SUSQUEHANNA STEAM ELECTRIC STATION, UNIT 1

AMENDMENT TO FACILITY OPERATING LICENSE

Amendment No. 174  
License No. NPF-14

This amendment changes the Susquehanna TSs to support the use of Siemens Power Corporation (SPC) ATRIUM<sup>TM</sup>-10 fuel design in the upcoming Cycle 11 refueling outage.

Figure 2.1.2-1  
MCPR Safety Limit vs Core Flow

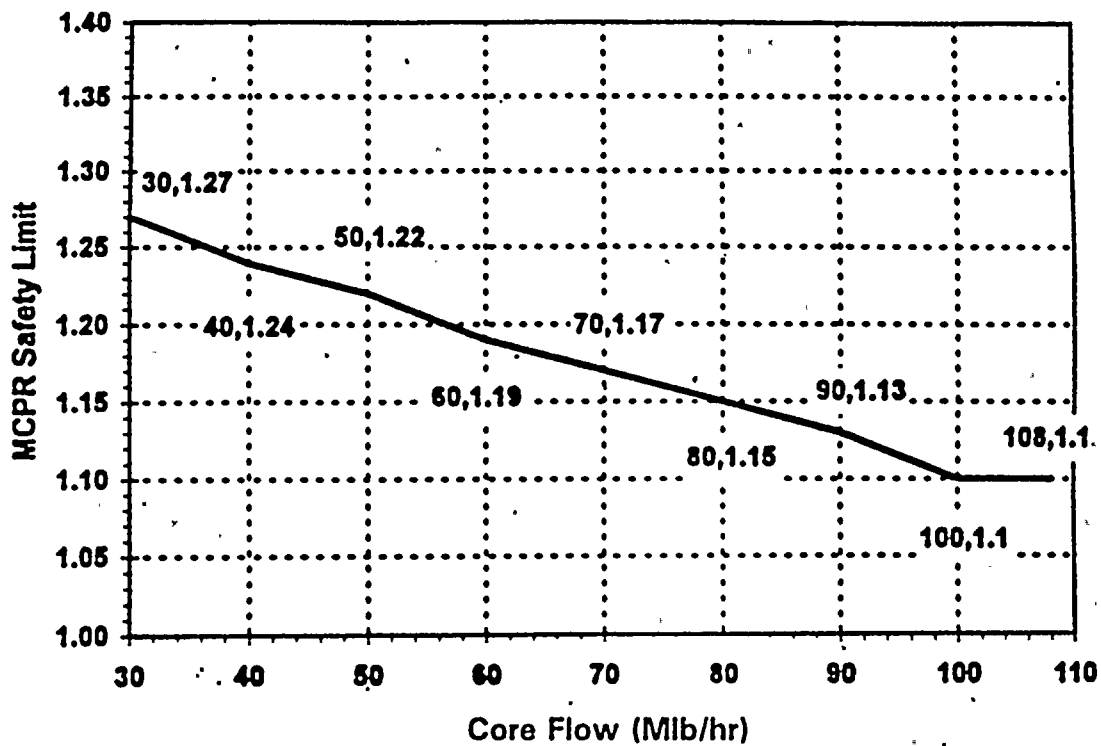
2.1.2 The MINIMUM CRITICAL POWER RATIO (MCPR) shall not be less than the value shown in Figure 2.1.2-1\*\* with the reactor vessel steam dome pressure greater than 785 psig and core flow greater than 10 million lbm/hr.

With MCPR less than the value shown in Figure 2.1.2-1\*\* and the reactor vessel steam dome pressure greater than 785 psig and core flow greater than 10 million lbm/hr., be in at least HOT SHUTDOWN within 2 hours and comply with the requirements of Specification 6.7.1.

Figure 3.4.1.1.2-1  
MCPR Safety Limit vs Core Flow  
Single Loop Operation

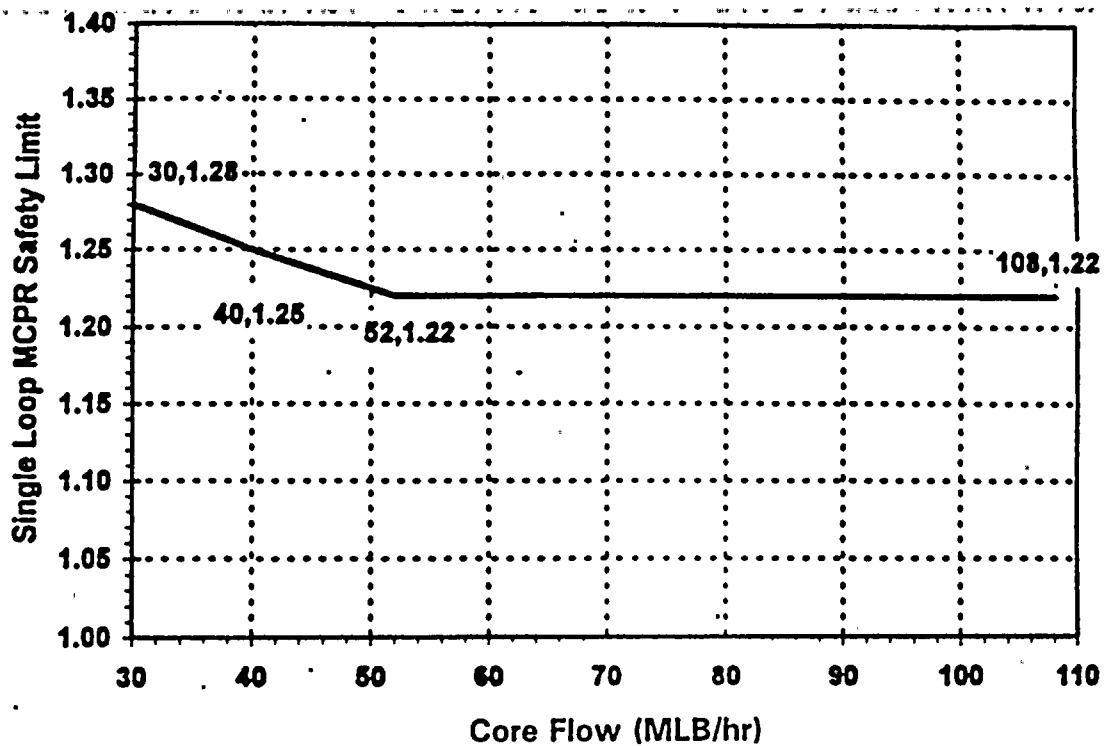
1. Specification 2.1.2: the MCPR Safety Limit shall be increased to the value shown in Figure 3.4.1.1.2-1<sup>++</sup>.
2. Table 2.2.1-1: the APRM Flow-Biased Scram Trip Setpoints shall be as follows:
